# Access Compliance Report

## Public Rights-of-Way

### (Curb Ramps)

Intersection ID: 16578	Main Street: CONWAY_AV	Cross Street: SCALEYBARK_RD	Location: S
ADA ID: CED98895D11B	Ramp Type: Directional1	Initial Pass/Fail: Pass	Overall Compliance: No
		Severity Score: 7.5

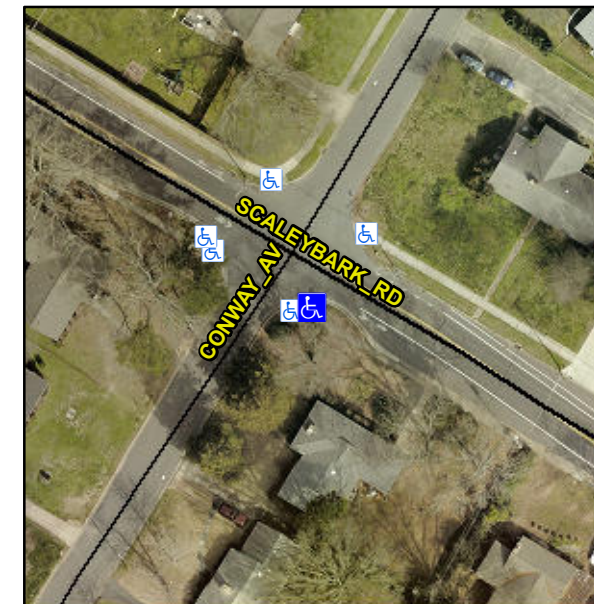
**Grind Gutter Lip.**

**R302.7.2**
